KTI Networks Important Notice

May 28, 2008

KGS-510F

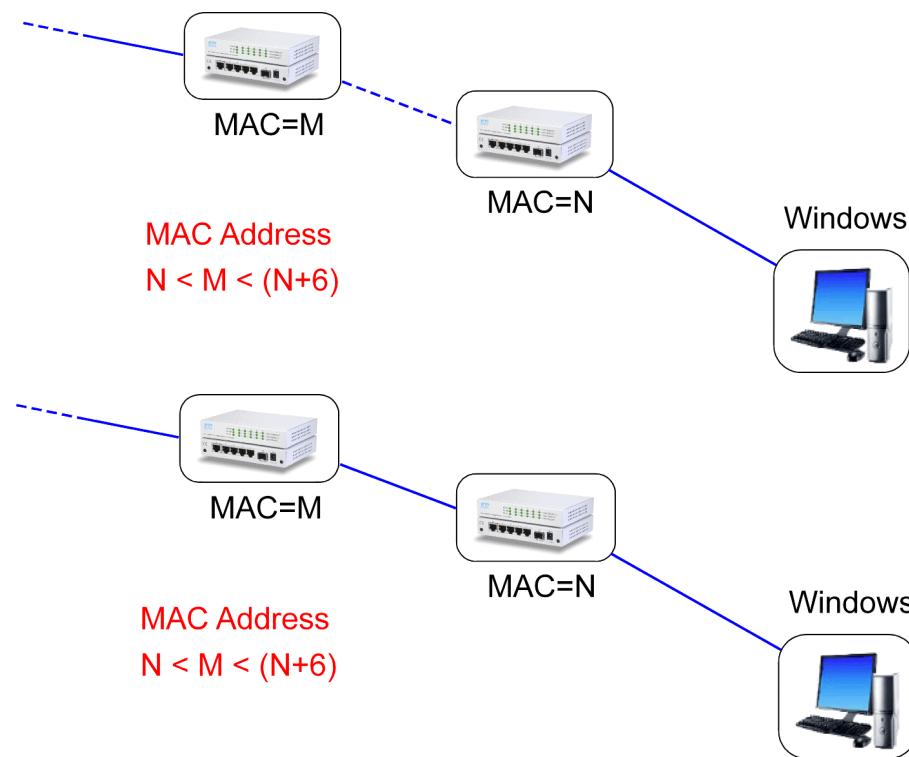
As two scenarios shown below, the Windows PC is unable to manage the Switch M via web browser or ping the Switch M through the Switch N if the Mac address M is within the range of N and N+6.

In both scenarios, the packet switching function on the Switch M and Switch N are with no problem but only management function.

Update the firmware v1.24 of the Switch N with firmware **Ver.1.25**.

Update the firmware v1.35 of the Switch N with firmware **Ver.1.36**.
